To: T10 Technical Committee  
 From: Rob Elliott, HP (elliott@hp.com)  
 Date: 2 June 2002  
 Subject: T10/02-198r2 SAS OOB timing

The OOB timing requirements need to be more precise, listing the transmit burst time and specifying receiver tolerances.

Also, the May T10 SAS study group chose to make the COMSAS burst time match the other OOB signals, with its idle time increased to 3x the COMINIT idle time.

**Figure 1. Phy reset sequence OOB signal generation-transmission and detection**

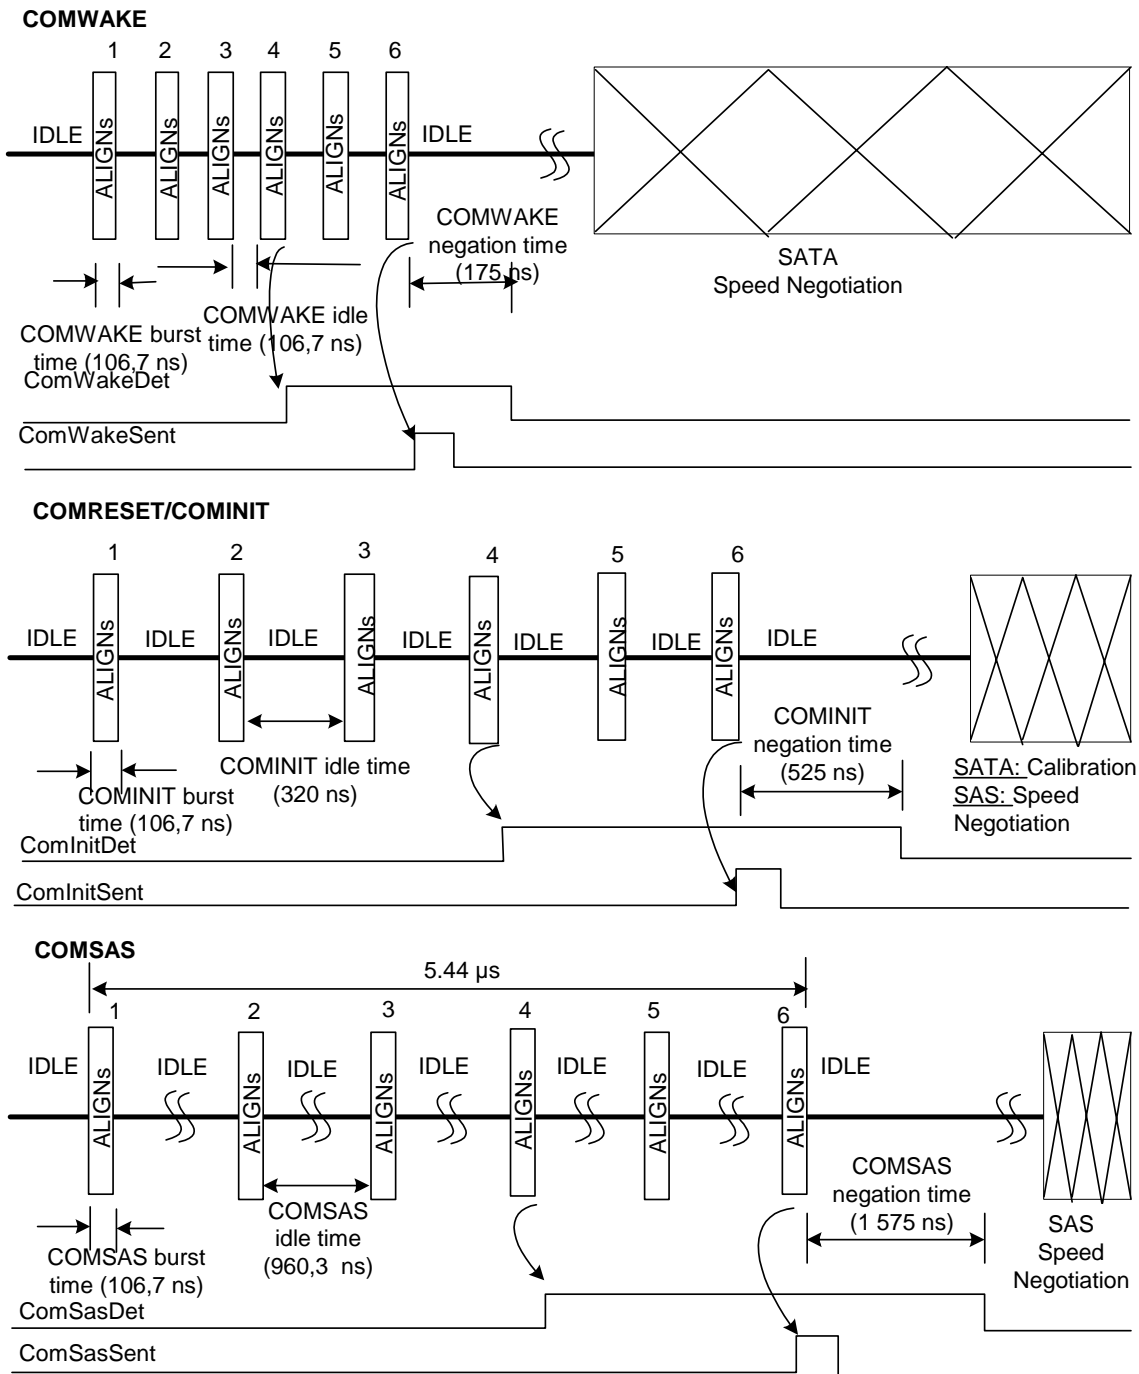
[Editor's note: change all figures to use the (new) acronyms rather than absolute times. If numbers are used, they should be in parenthesis as examples.]

Figure 1 illustrates the timing required for the generation and detection of all the SAS OOB signals. The signals labeled ComXxxDet and ComXxxSent (where Xxx is Wake, Init, or Sas), are inputs to the SAS phy ~~Initialization layer~~ state machine. ComXxxDet is an output from the OOB detection circuitry that indicates the detection of an incoming COMINIT, COMWAKE, or COMSAS ~~sequences~~ signal. ComXxxSent is an output from the OOB generation circuitry that indicates that a burst of six COMWAKE, COMINIT, or COMSAS ~~sequences~~ signals has been output onto the link.
